Street Improvement Permit

Address : 1101 CONNECTICUT ST

SFFD & Potrero Hope, Agreement Letter# 03

RE: Aerial Apparatus Access Roads – Operational Width

Figure 3.1 Site Plan – Design Modification Location Diagram

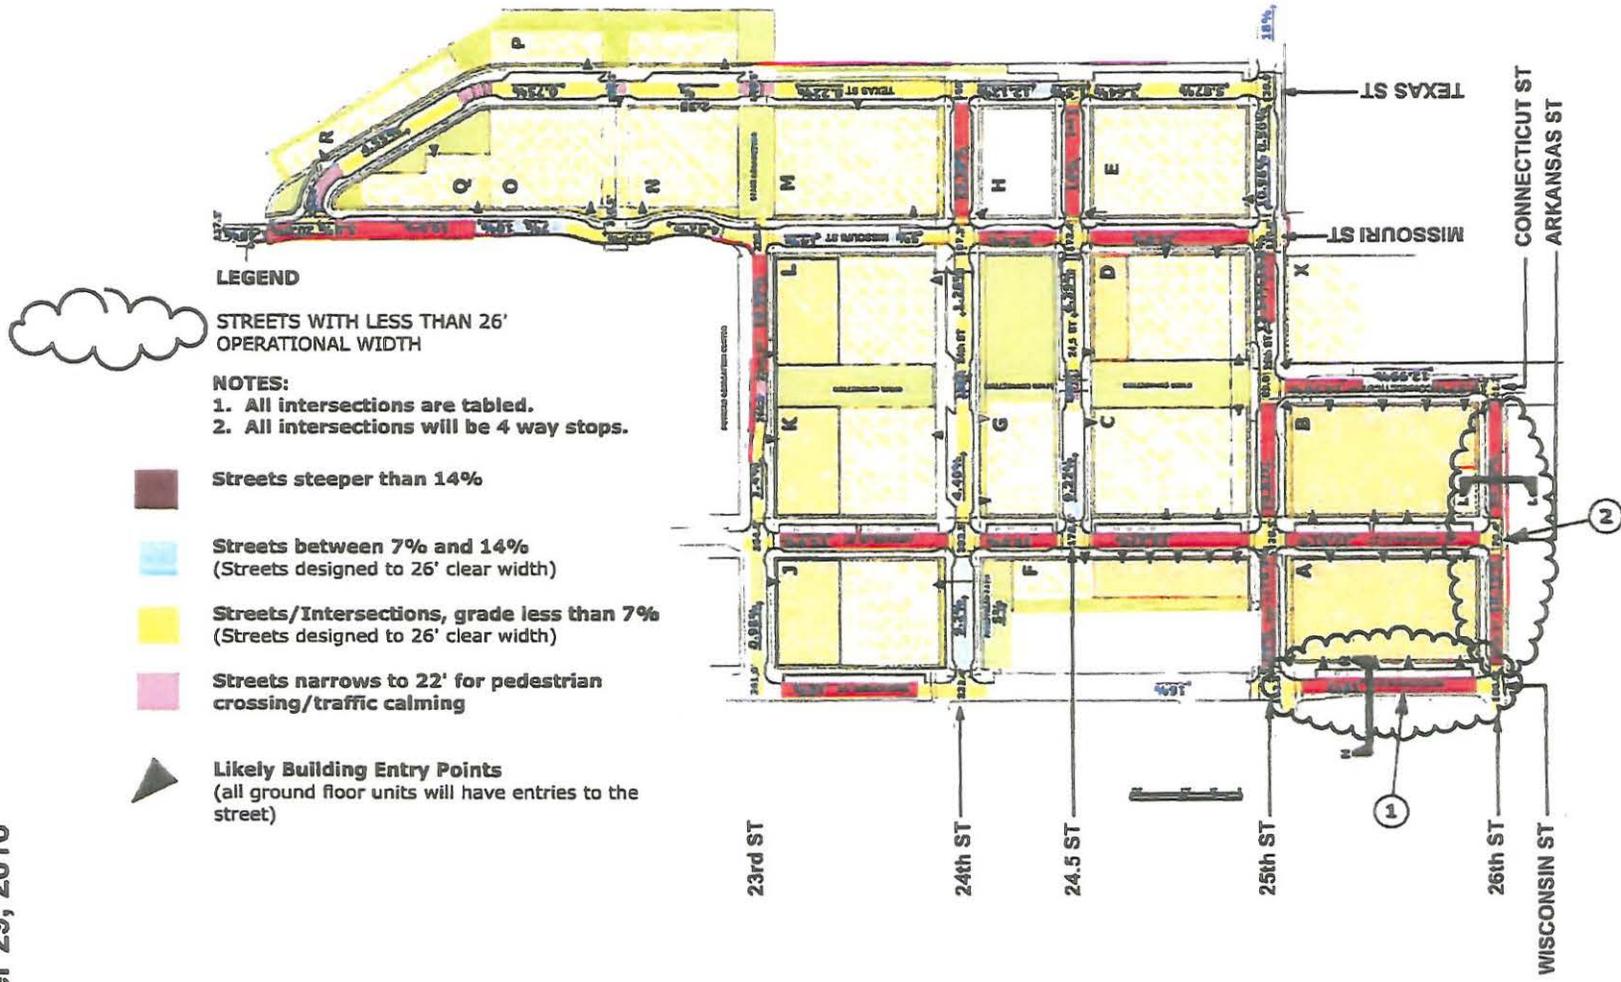
The San Francisco Fire Department grants the Potrero HOPE SF project, the following design modifications:

1. **Wisconsin Street** between 25th and 26th Streets shall have a minimum Operational Width of 25 feet.
 - a. All new construction to the east is under 40-feet in height limit.
 - b. Existing construction to the west is 2 stories.
2. **26th Street** between Wisconsin and Connecticut Streets shall have an Operational Width of 22 feet with no parking/stopping allowed on the south side of the street.
 - a. All new construction to the north is under 40-feet in height limit.
 - b. There are no structures, sidewalks, or parking to the south. Curbs will be painted Red – "No Stopping".

30' VERTICAL CURVE CHECK

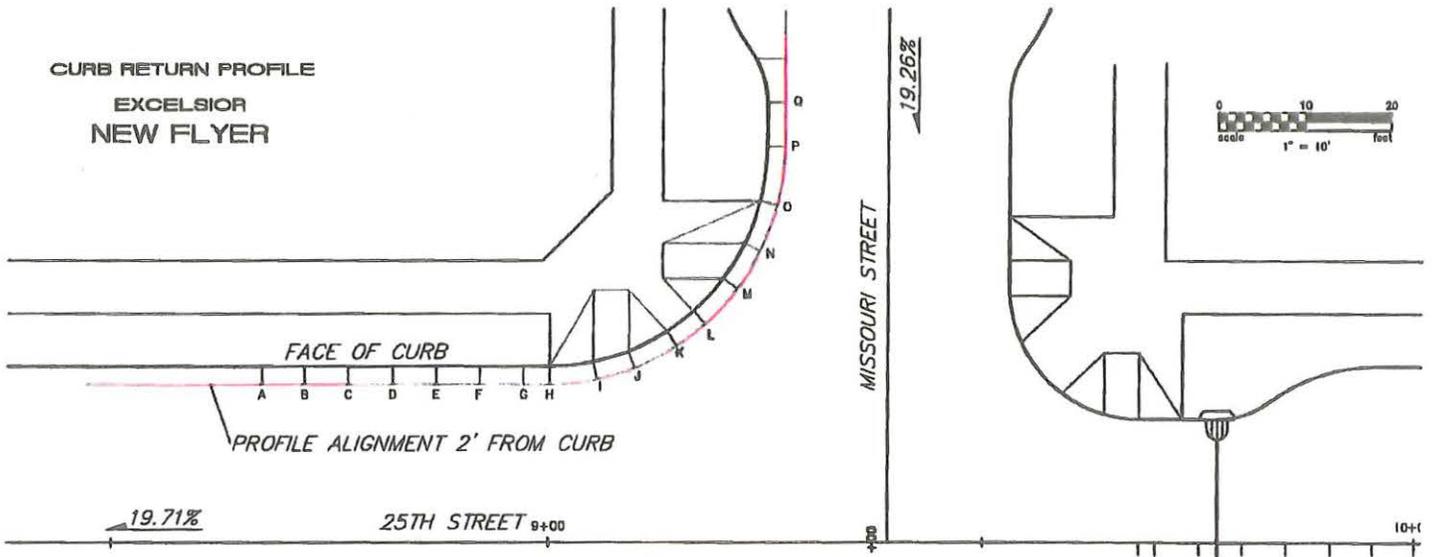
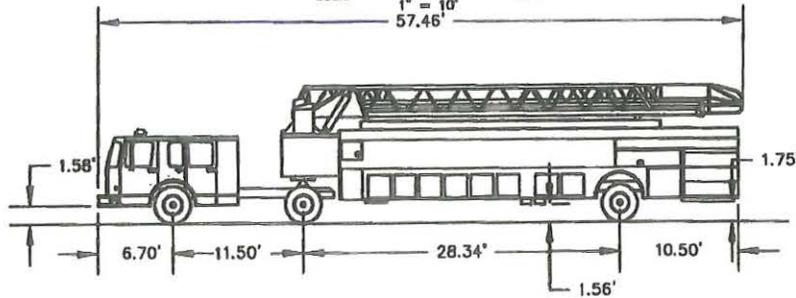
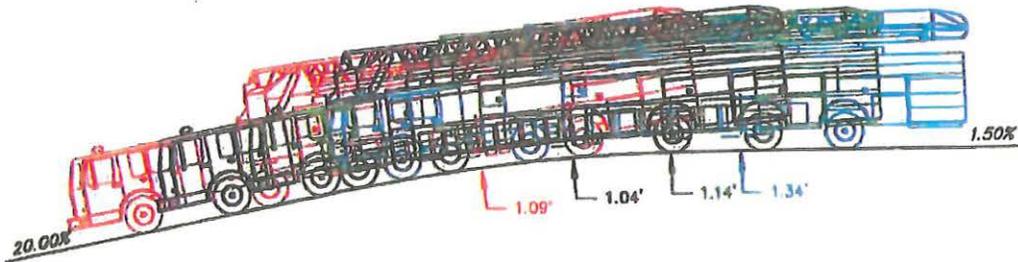
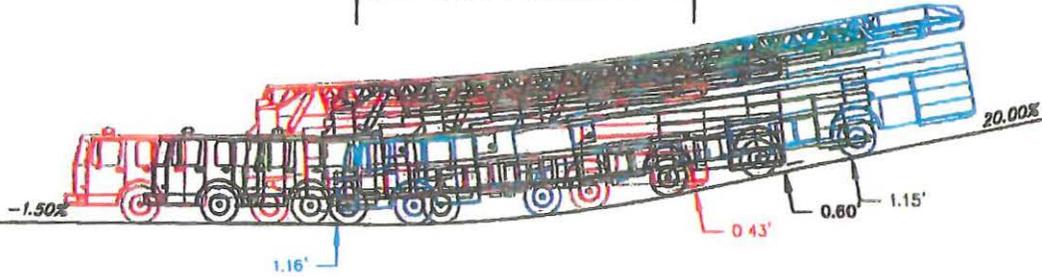
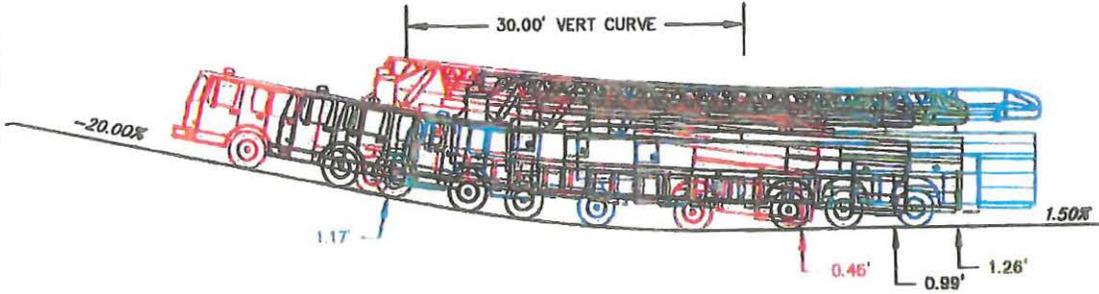
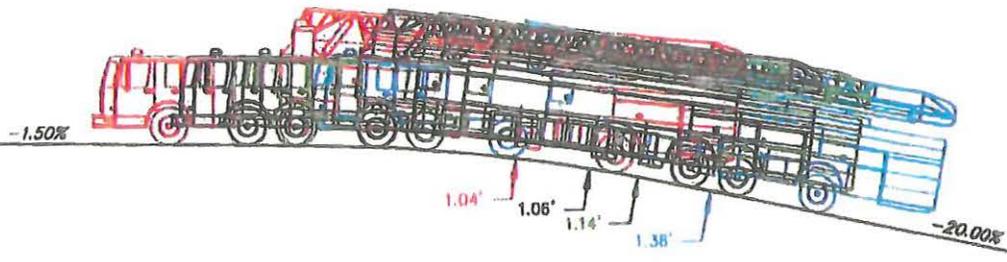
BRIDGE Housing is seeking the Design Modification due to the unusual conditions of the existing topography and the steep street grades that are needed to implement the plan. Half of the streets entering intersections in the project will consist of streets that are over 15% with tabled intersections that will slope at 1% – 1.5%. In order to keep the length of the tabled intersections to a minimum and allow the streets to more closely follow the existing slopes in the area, we propose that the project utilize a 30-foot vertical curve to transition between a maximum 20% street slope and a 1.5% tabled intersection. All of the intersections are intended to be all-way stops. BRIDGE is requesting a variance that will allow the use of a maximum absolute algebraic difference of 21.5% at the intersections, and use of a 30-foot vertical curve to transition between the two slopes.

The BRIDGE team has provided documentation to the DPW and SFFD for review including vertical curve diagrams for all of the SFFD vehicles. SFFD has reviewed the documents and have approved the 30-foot vertical curve design for PHASE 1. Once the roads in PHASE 1, Connecticut Street and 25th Street between Connecticut and Texas Streets, are developed, all parties involved will conduct a field operations test. The outcome of this test will determine the future vertical curves for the rest of the project. If the test fails, a redesign for the balance of the project will be required.

Figure 4.1 Site Plan – Design Modification Locations
RE: Aerial Apparatus Access Roads – Distance from Building Facade
February 24, 2016

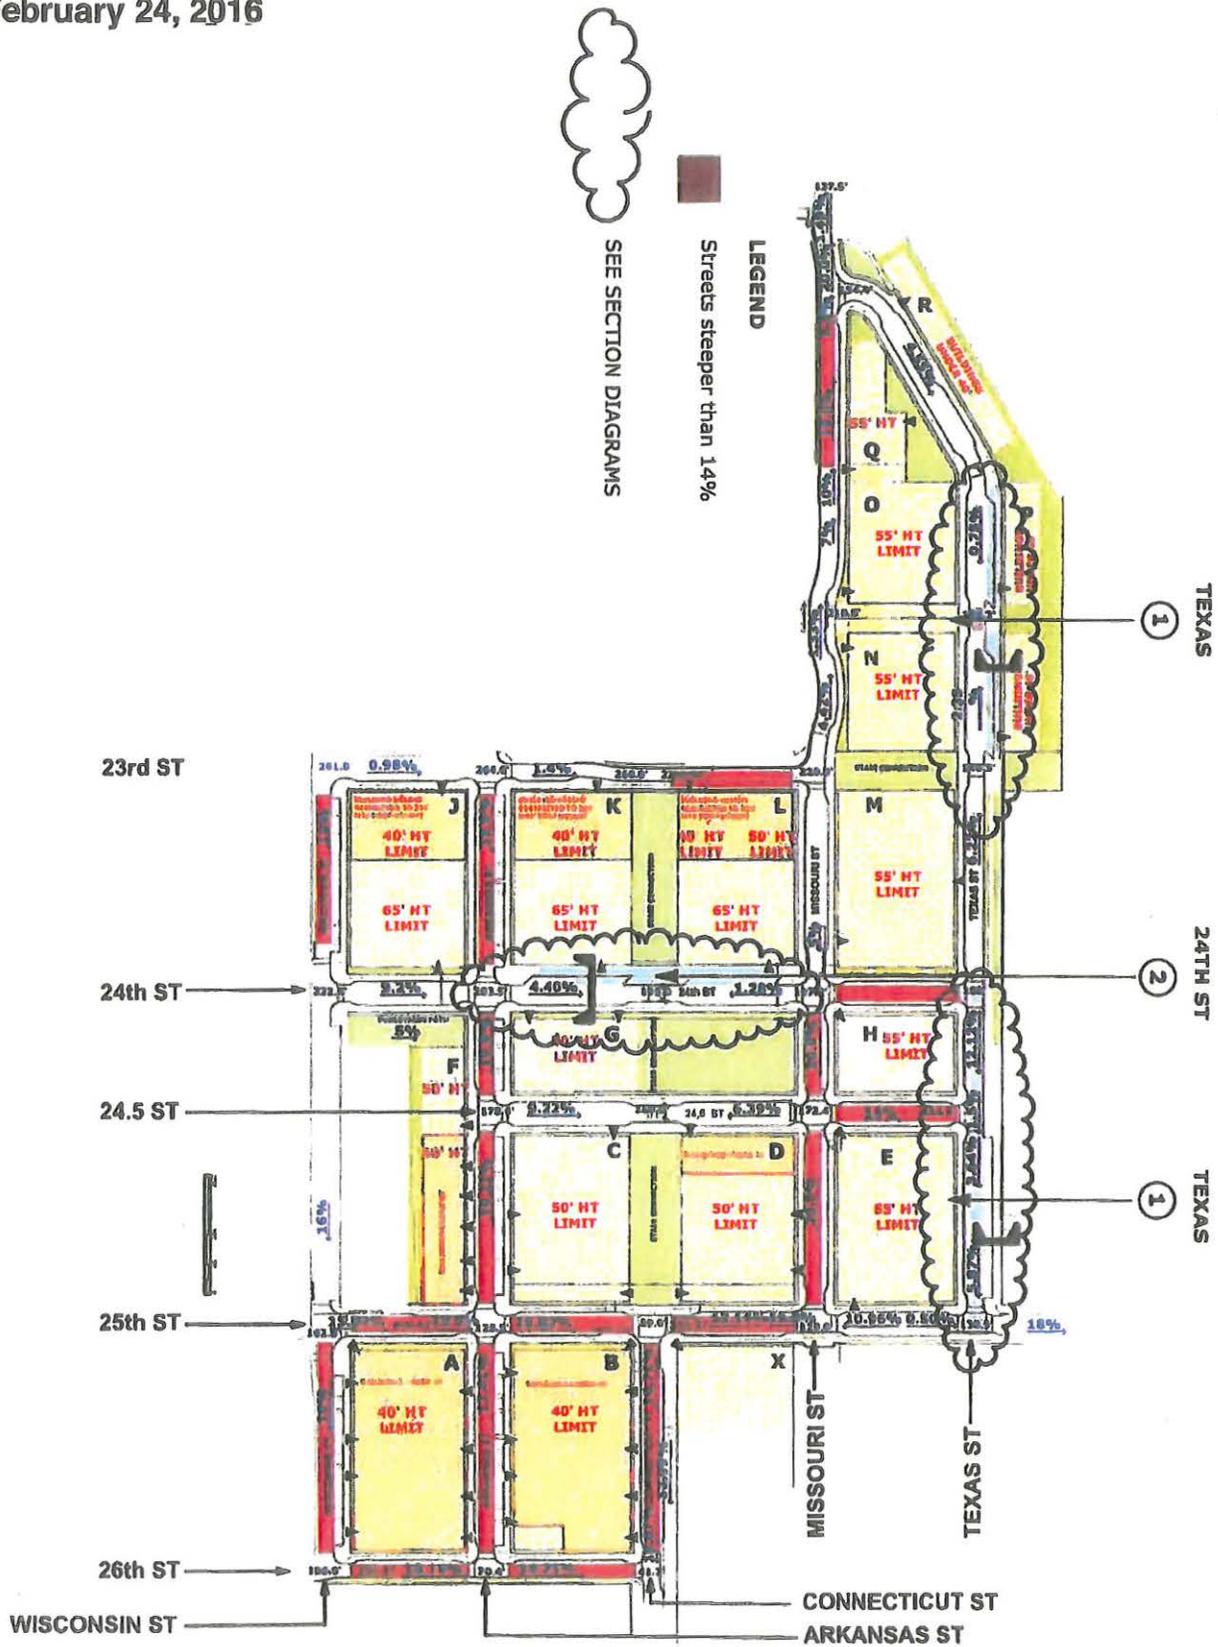
- A. Where perpendicular and diagonal parking is provided, the Aerial Apparatus Access Road shall be no greater than 35 feet from the main façade of the building.

BRIDGE Housing is seeking this design modification in 3 locations:

Location 1: 24th Street between Arkansas and Missouri Streets on the mixed-use retail street. See attached diagram for section showing adequate access for fire ladder to the roof. Street grades are less than 7%.

Location 2: Texas Street south of 24th Street. This existing and new condition has perpendicular parking and buildings up to 55-feet in height. Street grades vary. See attached diagram for section showing adequate access for fire ladder to the roof.

Location 3: Texas Street north of 23rd Street Stair. This condition has 3-4 story buildings, under 40-feet in height, approximately 33' from fire access way. See attached diagram for section showing adequate access for fire ladder to the roof.
